Technical Review Committee

**CITY OF DELAND
WEDNESDAY JUNE 18, 2025 AT 1:30 P.M.
CITY OF DELAND TRC MEETING ROOM
DELAND, FLORIDA**

City of DeLand
SP24-134
New York Ave
Apartments

Issues for record SP24-134
Job Address: 225 W NEW YORK AV, DELAND FL 32720
Job Description: 84 multi-family unit apartment development

City of DeLand
SP25-037
JACOB'S HEATING & AIR
SHARED DRIVEWAY

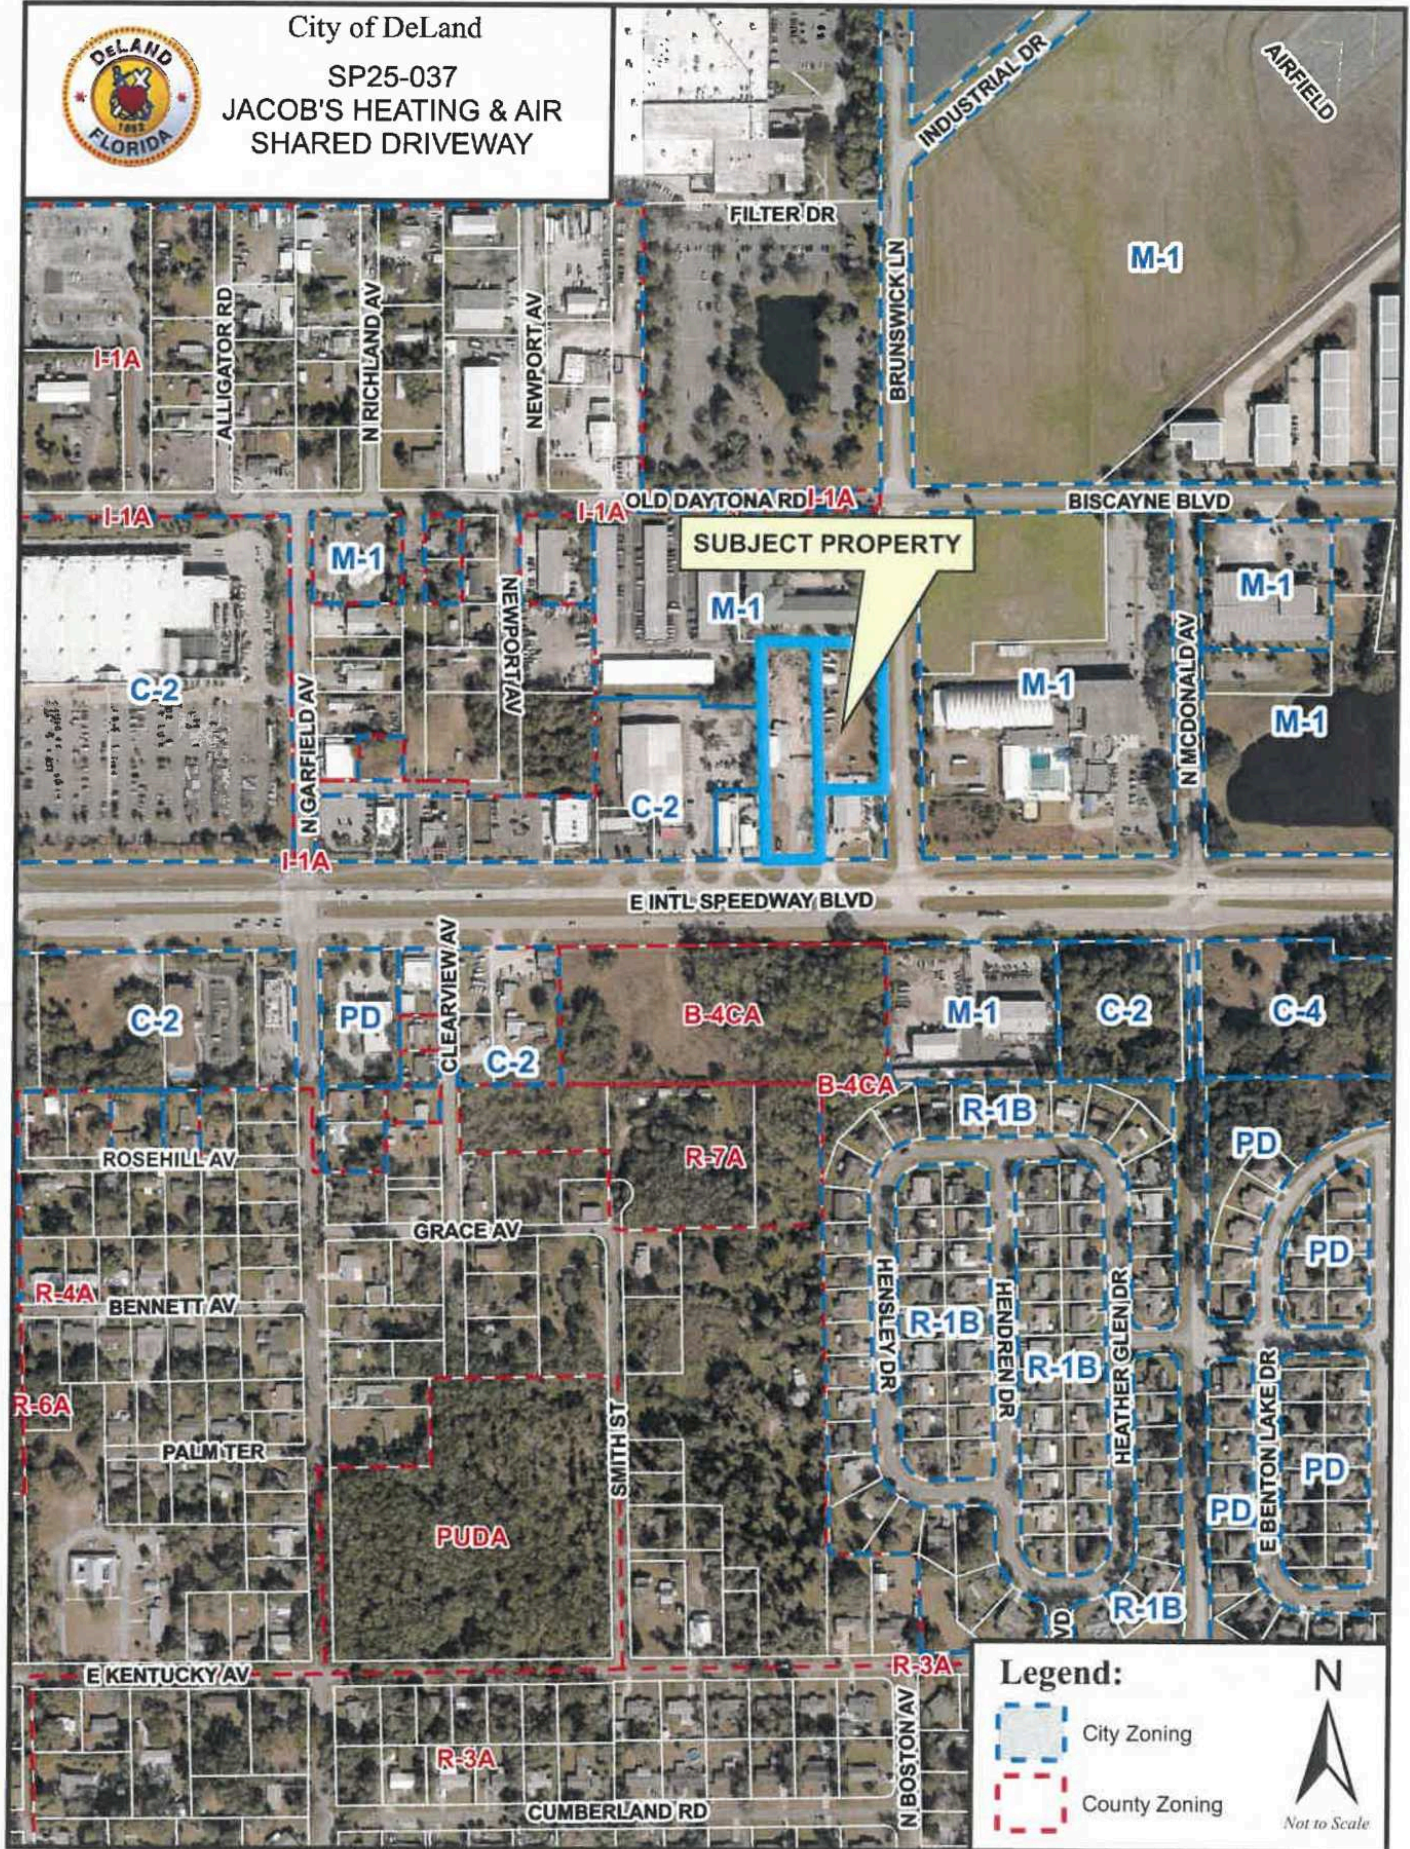
Discipline	Status	Details	Attached To	Created By	Last Updated By	Modifications Required
Concrete Driveway						
Engineering	Draft	1. It is strongly recommended that unless a Geotechnical analysis is performed that the driveway also be constructed with 6-inch thick, 3,000 psi concrete, due to the likelihood of truck traffic utilizing the driveway. At a very minimum, 5-inch thick, 3,000 psi concrete should be utilized. 2. The Concrete Apron hatch should extend across the driveway apron. 3. The culvert should show up in the cross section. 4. Provide a note that a signed and sealed as-built topographic survey is required to be submitted to the City Engineering Dept. prior to acceptance.	C.2	Steven Danskine	Steven Danskine	Yes
TPA						
Forestry	Draft	Designate 15% Tree Protection Area location. If project area is 2.44 acres, 15,943 sf of project area will need to be designated as Tree Protection Area (.37 acres).	C.1	Belinda Collins	Belinda Collins	Yes

Landscape plan						
Forestry	Draft	Please provide a landscape plan showing all trees required to be planted to meet minimum coverage and to provide replacement for any trees that may be required to be removed.	C.1	Belinda Collins	Belinda Collins	Yes
INCHES REMOVED						
Forestry	Draft	1. Provide information on the number of inches being removed – Cherry laurel, cabbage palm. (Camphor trees are exempt.)	C.1	Belinda Collins	Belinda Collins	Yes
TREE WORKSHEET						
Forestry	Draft	1. Provide a tree worksheet to determine what needs to be replaced. (A quick review based on the size of the property shows that 43 trees are required to meet the 1/2500 sf requirement.)	C.1	Belinda Collins	Belinda Collins	Yes
TREE SURVEY						
Forestry	Draft	1. Provide a tree survey to demonstrate how much replacement should take place. There are a number of trees along the right-of-way on Brunswick and there could potentially be enough vegetation to off-set those being removed.	C.1	Belinda Collins	Belinda Collins	Yes

YMCA Driveway						
Planning	Draft	Please show the access point for the YMCA and confirm the driveways are in-line.	C.2	Samuel Nelson	Samuel Nelson	Yes
Traffic Pattern						
Planning	Draft	What is the intended traffic pattern for trucks entering and exiting the site? Please provide a narrative or plan detailing the proposed traffic pattern.	C.1	Samuel Nelson	Samuel Nelson	Yes

Discipline	Status	Details	Attached To	Created By	Last Updated By	Modifications Required
Planning	Draft	Cross-Access Easement Please show the cross-access easement between Parcels 1&2 on the site plan and provide recordation book and page numbers on the plan.	C.1	Samuel Nelson	Samuel Nelson	Yes
Planning	Draft	Impervious Totals Please provide the total new impervious proposed for each parcel separately and provide the total impervious area for the developed parcel.	C.2	Samuel Nelson	Samuel Nelson	Yes
Planning	Draft	Parking Area Please indicate the intended parking area and provide striping for any existing or proposed parking spaces.	C.1	Samuel Nelson	Samuel Nelson	Yes
Planning	Draft	Milled Asphalt Milled asphalt is not permitted to be used for vehicle use area. Please remove the milled asphalt area from the plan.	C.1	Samuel Nelson	Samuel Nelson	Yes

City of DeLand
FSB25-081
WOODLAND COMMERCIAL
REPLAT

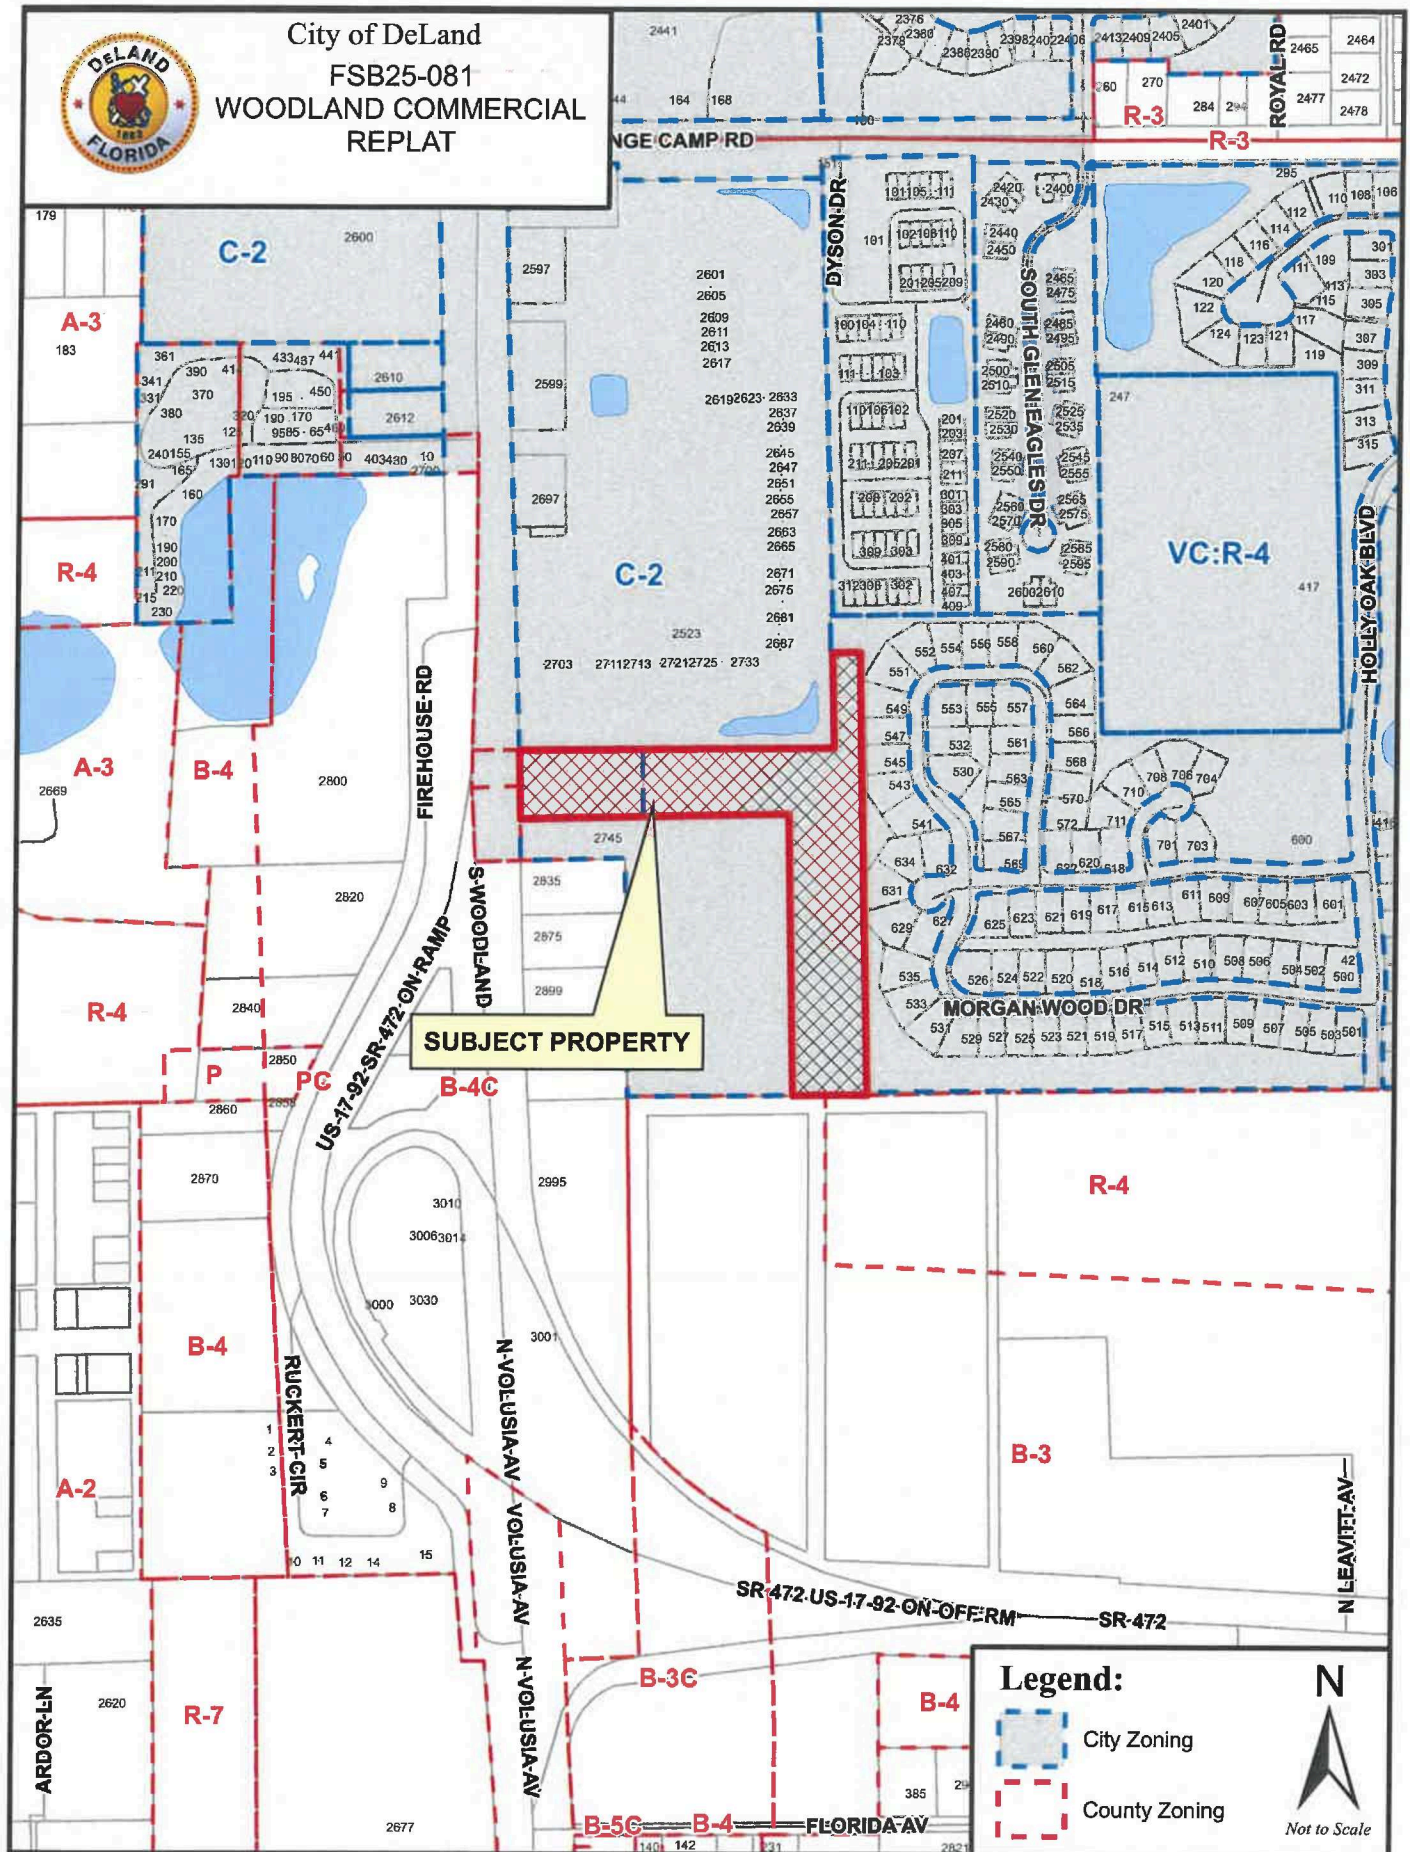
Discipline	Status	Details	Attached To	Created By	Last Updated By	Modifications Required
Forestry	Draft	TPA Sheet 2 of 3 change TREE PRESERVATION Tracts to TREE PROTECTION AREA to be consistent with Code language.		Belinda Collins	Belinda Collins	Yes
Planning	Draft	Current & Proposed Legal Descriptions In the legal description, please describe both the current legal description and the new legal description of the property and state that one is replacing the other.	1	Kendall Story	Kendall Story	Yes
Planning	Draft	Add General Notes A _____ foot ingress/egress access easement is needed. Please note this in the General Notes section.	1	Kendall Story	Kendall Story	Yes
Planning	Draft	Cross-Access Easement & Maintenance A cross-access easement for the benefit of Lot 2 is needed. Any other shared facilities such as stormwater retention must be recorded. In the dedication language on the front page, the dedication and maintenance language for the access/stormwater/etc. easements must be noted.	2	Kendall Story	Kendall Story	Yes

Planning	Draft	Easements depicted on plat All NEW easements must state "to be dedicated by this plat". All OLD easements must have an ORB and page referenced. All easements being VACATED by the plat must say "to be vacated by this plat". Will the 50' wide construction easement remain?	2	Kendall Story	Kendall Story	Yes
Planning	Draft	Easement book & page Need OR book and page for all existing easements. Need to label easement type/use for any new easements. Please see plan markups.	3	Kendall Story	Kendall Story	Yes
Planning	Draft	No longer in a PD (See note #7) The property will no longer be regulated by the Mainstreet Townhomes PD as it is being rezoned prior to the final plat approval.	1	Kendall Story	Kendall Story	Yes
Planning	Draft	Easements in notes On the front page, under General Notes, list and describe each easement shown on the plat.	1	Kendall Story	Kendall Story	Yes
Planning	Draft	Owner name Name of owner should be West Volusia Storage, LLC (see the dedication block).	1	Kendall Story	Kendall Story	Yes

City of DeLand
Z25-084
REZONING FOR
DELAND CROSSINGS

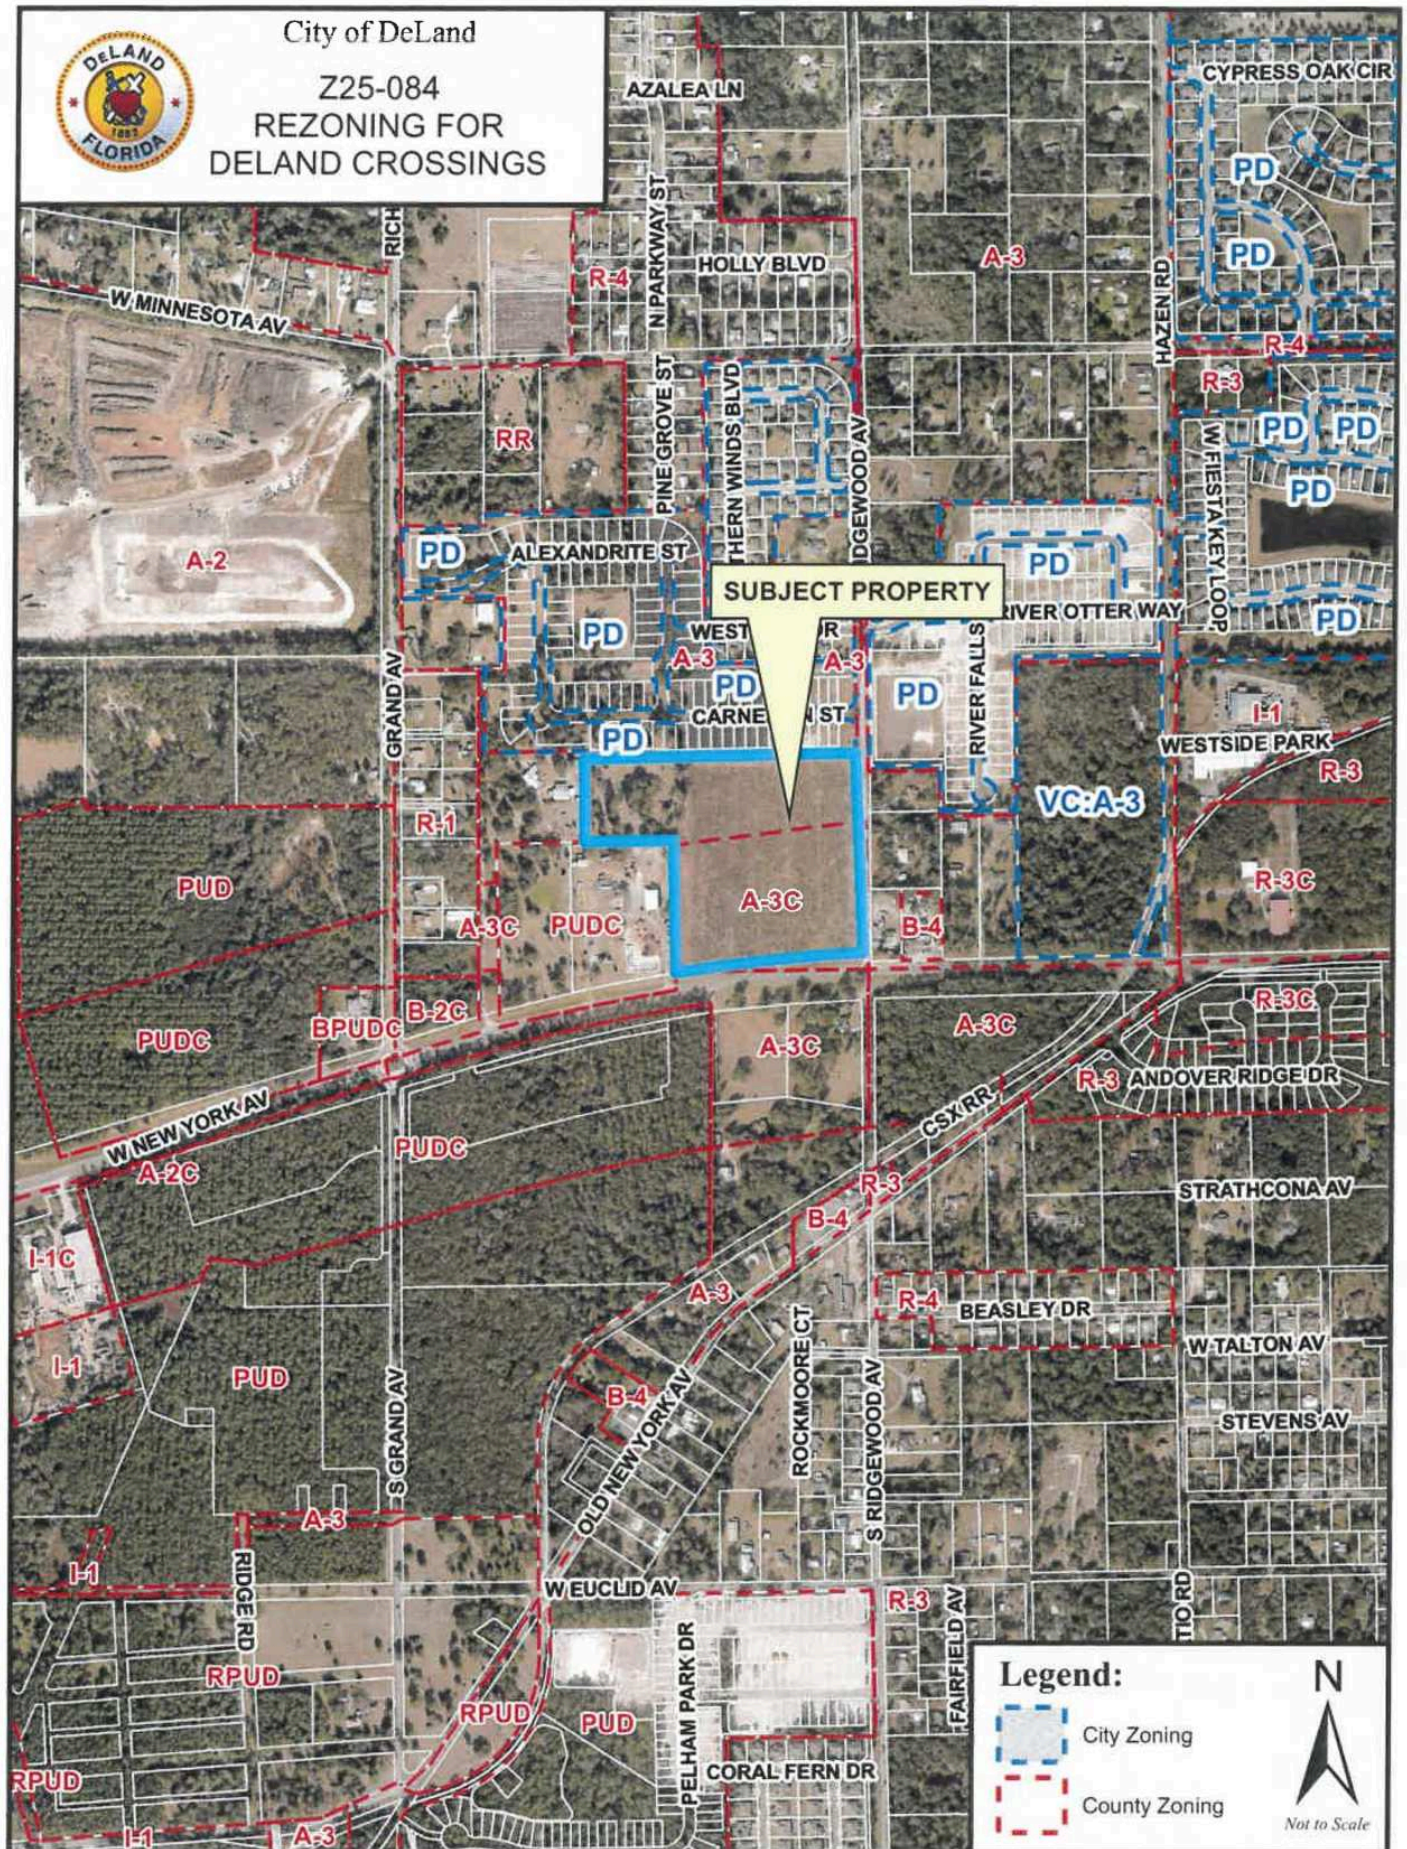
Discipline	Status	Details	Attached To	Created By	Last Updated By	Modifications Required
Engineering	Draft	Utilities & Maintenance Suggest making the retention area maintenance berm and Utility Easements 10' wide.	C5	Steven Danskine	Steven Danskine	Yes
Engineering	Draft	Stormwater Maintenance Item K identifies that the LID Elements shall be maintained by the HOA, but it is not clear that the stormwater system shall also be maintained by the HOA. Please clarify this requirement.	DeLand Crossings PD Agreement Final 5-5-25.pdf	Steven Danskine	Steven Danskine	Yes
Forestry	Draft	Tree Survey Requirements City Code requires a tree survey of all trees 6" DBH or larger. Page 9, #6, lines 24 to 26 suggest that a survey of only specimen and historic trees may be acceptable. If you are proposing an actual tree survey for all specimen and historic trees and a statistical survey to account for impacts to other protected trees, please describe the methodology proposed for the statistical survey. Forestry staff does not support waiving survey requirements for protected trees that are less than specimen size.	DeLand Crossings PD Agreement Final 5-5-25.pdf	Mariellen Calabro	Mariellen Calabro	Yes

Sheet C4						
Forestry	Draft	1. Tree protection area – 15% of the site (3.02 acres) is required to be set aside for TPA. Identify where the TPA is to be located on this site. 2. Provide a plant schedule listing all plantings including shrubs, etc. and their sizes. 3. Provide an irrigation plan. 4. Provide a list of landscape details showing how the plantings will be installed. 5. There are a couple of plants that appear to be located within the right of way of the southernmost road.		Belinda Collins	Belinda Collins	Yes

Sheet C3						
Forestry	Draft	1. Tree protection area – 15% of the site (3.02 acres) is required to be set aside for TPA. Identify where the TPA is to be located on this site. 2. Provide a plant schedule listing all plantings including shrubs, etc. and their sizes. 3. Provide an irrigation plan. 4. Provide a list of landscape details showing how the plantings will be installed. 5. There are a couple of plants that appear to be located within the right of way of the southernmost road.		Belinda Collins	Belinda Collins	Yes

Discipline	Status	Details	Attached To	Created By	Last Updated By	Modifications Required
Cover -						
Forestry	Draft	1. Provide a tree worksheet to determine what needs to be replaced. (33-57.07 (a) 2 "Tree replacement requirement. If a lot or parcel contains an insufficient number of existing trees to meet the requirement of this section, a replacement tree shall be provided for every 2,500 square feet of lot or parcel area.") 2. Identify the species of oak trees listed in the tree table. Live oaks 10"+ are considered specimen, 25"+ are historic.		Belinda Collins	Belinda Collins	Yes
Mid Block Crossing						
Planning	Draft	Coordinate with Volusia County Traffic Engineering and FDOT for an enhanced pedestrian crossing to the south side of the development to meet the regions safety goals.	25045 C1 PD Site Plan 05-02-2025.pdf	Emily Ragusa	Emily Ragusa	Yes
Sidewalks						
Planning	Draft	Increase the 5-ft sidewalks to 6-ft along the project perimeter	25045 C1 PD Site Plan 05-02-2025.pdf	Emily Ragusa	Emily Ragusa	Yes

Open Space Min						
Planning	Draft	Increase to 40% open space minimum	25045 C1 PD Site Plan 05-02-2025.pdf	Emily Ragusa	Emily Ragusa	Yes
Project Area						
Planning	Draft	Provide the gross and net area of the project in addition to the area of the ROW dedication	25045 C1 PD Site Plan 05-02-2025.pdf	Emily Ragusa	Emily Ragusa	Yes
Street Trees						
Planning	Draft	Add a note on the landscape plan that states "Street trees may be planted within the rights of way within the Property and said trees may be included in mitigation calculations. The HOA shall be responsible to repair any and all impacts upon the right of way infrastructure created by the presence of said trees, including any road or sidewalk facilities."	25045 C3 PD Pre Landscape Plan 05-02-2025.pdf	Emily Ragusa	Emily Ragusa	Yes
Buffers						
Planning	Draft	The west buffers will need to be increased to at least a 30-ft a type D buffer with a 100% opaque screen wall.	25045 C3 PD Pre Landscape Plan 05-02-2025.pdf	Emily Ragusa	Emily Ragusa	Yes
